## Product Change Notice:

1001-011-01101: Molding/tooling modifications:

### **For USB connector 1001-011-01101 – with date codes AFTER 20/01:**

Adjusted/new PCB layout:

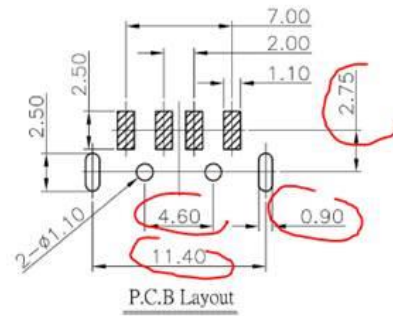
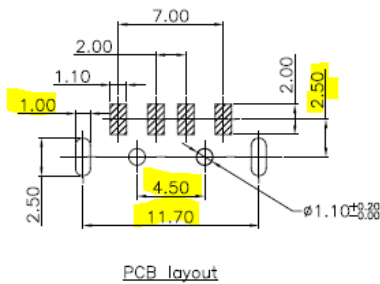
Tooling for 1001-011-01101 (CONNECTOR USB, 1.1, 4P, A/M, ULTRA FLAT, 1μ", SMT, R/A, HORIZONTAL) had to be adjusted, which created slight changes on the PCB layout.

.X = +/- 0.20mm

.XX = +/- 0.15mm
